UNITED STATES PATENT AND TRADEMARK OFFICE

10/560,148

Office Action Summary

DETAILED ACTION

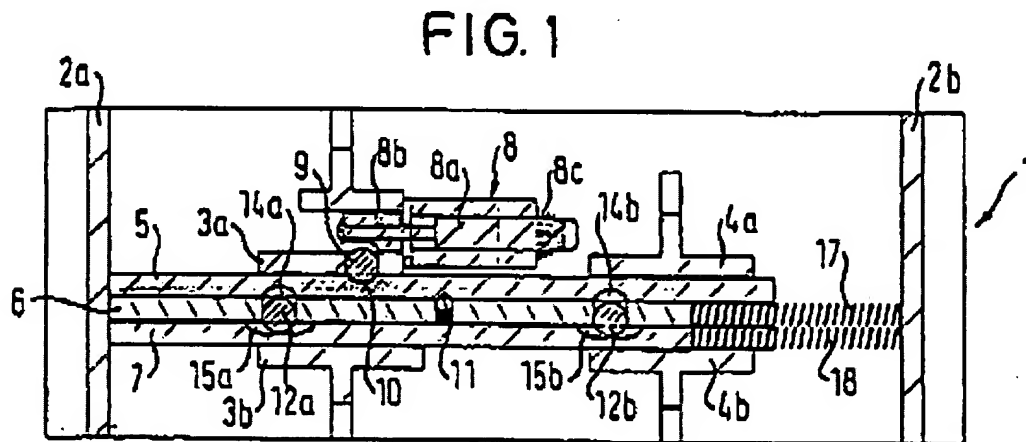
13. Regarding claims 4 and 12, Engler in view of Goldman, Goldman shows the shield as applied to claim 1 above but fails to mention the thickness of the material. The claimed thickness of "at least 0.8mm" is considered mere design choice. It would be

obvious to one of ordinary skill in the art to make the shielding element greater than 0.8mm in order to provide a structure strong enough to protect the magnet.

14. Regarding claims 5 and 13, "as best understood", it would be obvious to one of ordinary skill in the art that when modifying the Engler device to include a shield, that the electromagnet supports the shield. The shield must go on top of the magnet to protect it.

Engler

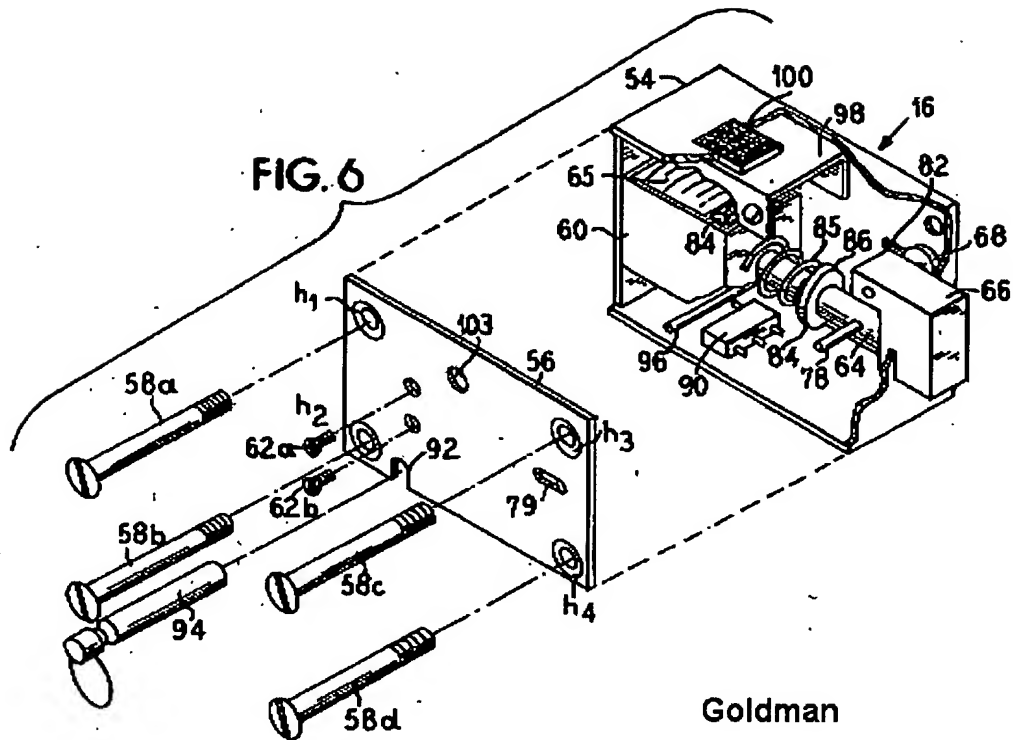
10. Regarding claim 1, Engler shows a lock with a bolt (7, see figures 1 and 6) arranged in a lock housing (1), wherein the bolt can be shifted between an opened position and a closed position by a closing element (5), wherein in the closing position the closing element can be blocked by a blocking element (8b, 9, 10), and the blocking element is coupled with an armature (8a) of an electromagnet (8) and can be actuated by the armature. Engler fails to show a shield for the electromagnet. Goldman shows that it is well known in the art to provide a shield for the electromagnet in addition to the housing. Goldman shows a lock having an electromagnet (65) covered by shield (98) to protect the magnet. Although Goldman fails to specifically describe the material of the shield, it would be obvious to make the shield from a low-retentive magnetic material in order to avoid interference between the shield and the electromagnet.

11. Regarding claim 2, Engler in view of Goldman, Engler shows the housing having a connecting side (left side of housing, figure 8) on which lock-operating elements (wires, 21) are arranged.

12. Regarding claims 3 and 11, Engler in view of Goldman, Engler shows the housing is closed by a cover (1a).

magnet (65), the lock comprising a control device (control unit, 18) which can be adjusted by a keypad (38) assigned to the magnet in which code information is storable which in case of renewed input and after being checked by the stored code information is used for controlling the magnet. Although Goldman does not specifically point out that the locking system includes a control knob, he includes that it is to be used on an apartment door (column 2, lines 60-64). It is well know in the art that an apartment door includes a control knob for operating a bolt. See the Engler and Goldman devices below.
